Viewerslaten 25/9  
Mulder.

This plan, delivered the 13<sup>th</sup> September 1892 by me at the request of the builder Mr. J. Mulder at Viewerslaten, in view of a reduction in the length of the main hatchway, proposed to him by the owners Mr. J. L. H. & Co. was not carried out, but the original decision of the Committee of the 10<sup>th</sup> August 1892, on a main hatchway, requiring two webframes on each side, has been retaken and constructed in conformity with the approved plan, marked A.

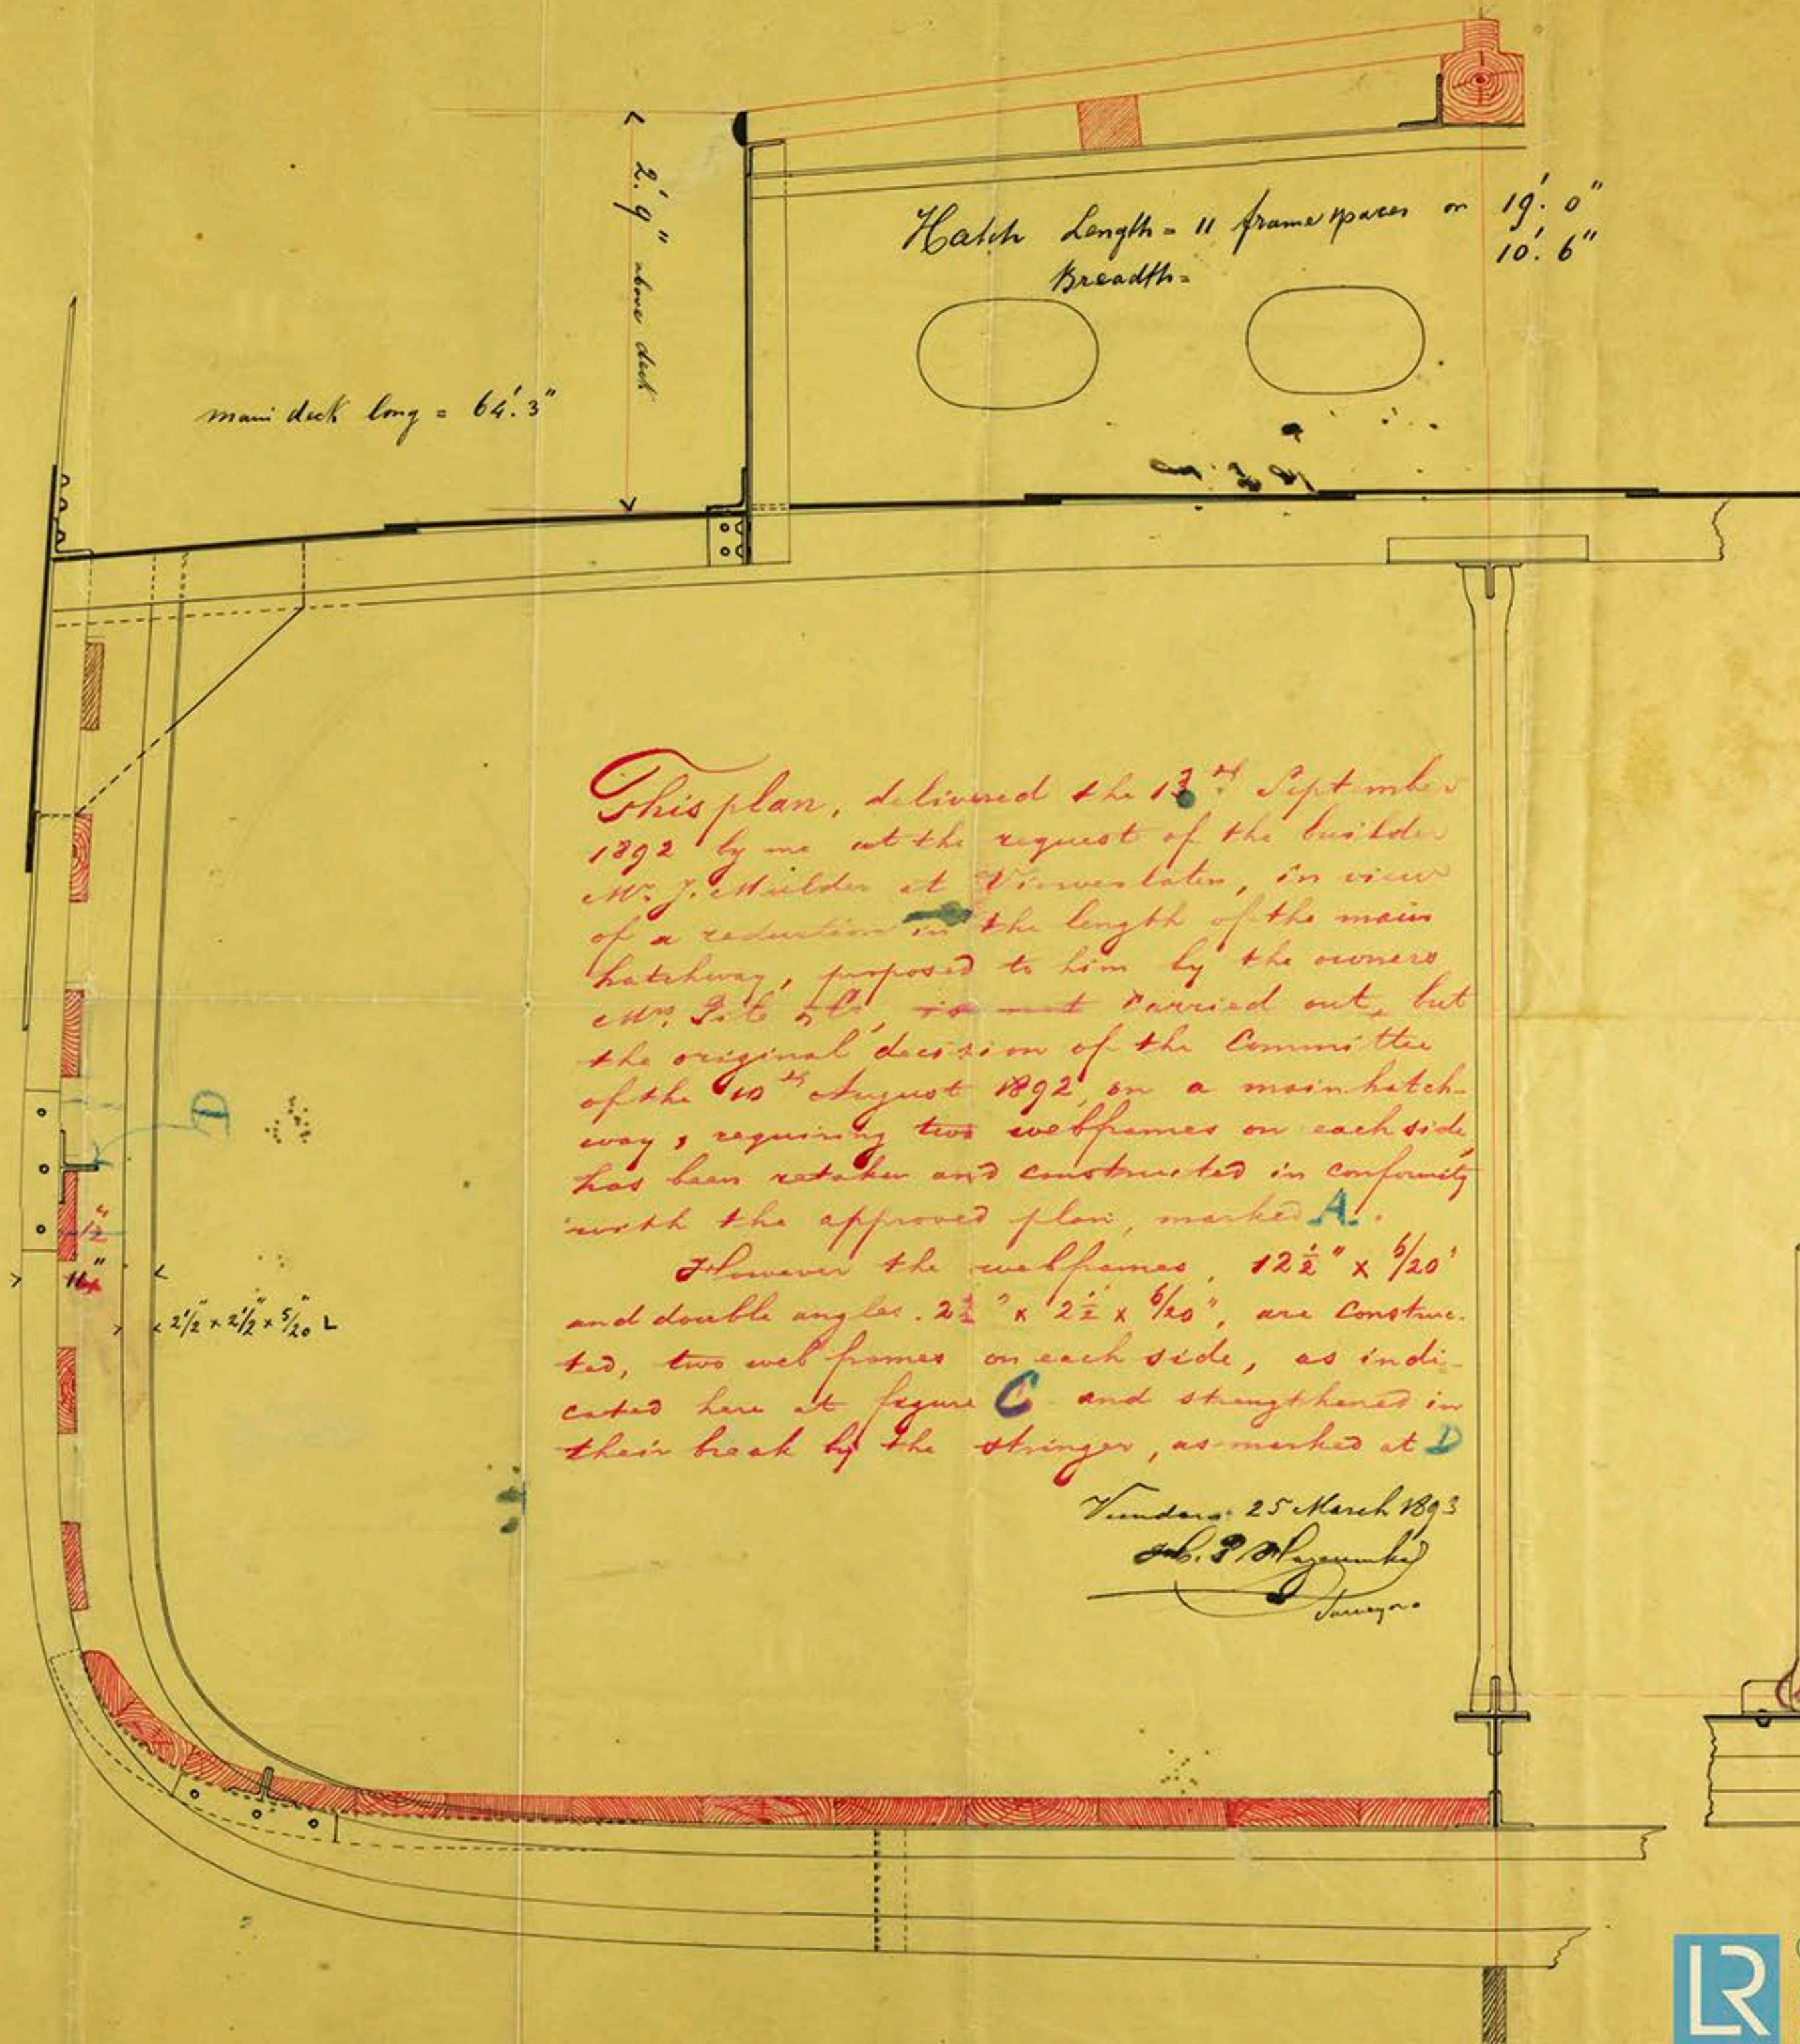
However the webframes, 12 1/2" x 6/20' and double angles, 2 1/2" x 2 1/2" x 5/16", are constructed, two webframes on each side, as indicated here at figure C and strengthened in their back by the stringer, as marked at D.
